ADD26588
RR-2.5
PLAT - 1694

APPROVED Plan Review
09/28/2023 2:48:49 PM
J. Blumm
EPC Planning & Community Development Department

SITE PLAN:

MONUMENT DETACHED GARAGE

SITE PLAN
SCALE 1" = 30'-0"

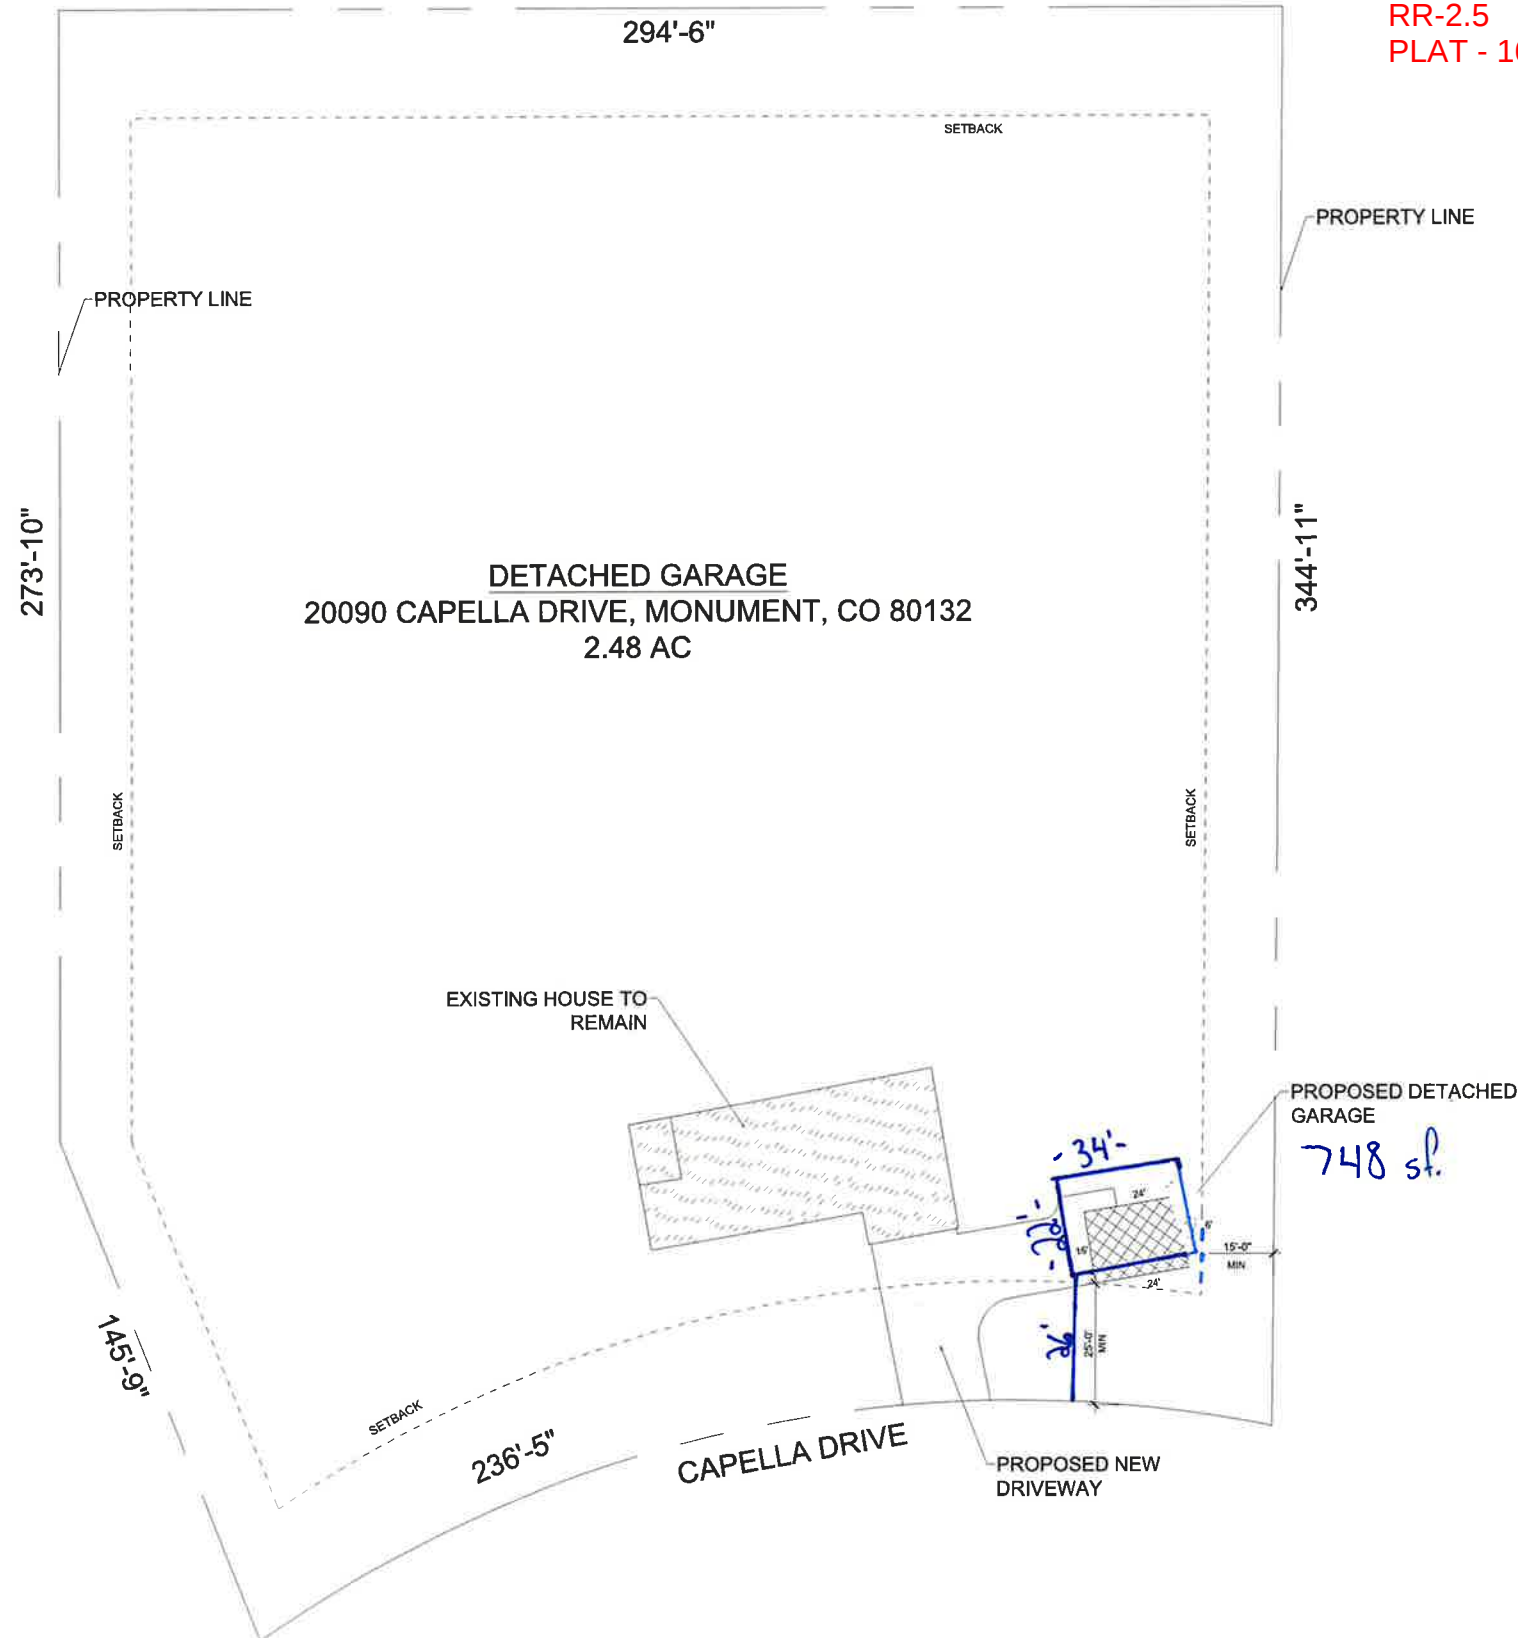
This parcel is in a low/moderate/high intensity fire risk area. Please reach out to the local fire district regarding recommendations for compliance with the WRC code.

It is the owner's responsibility to coordinate with easement holders to avoid impact to utilities that may be located in the easements.
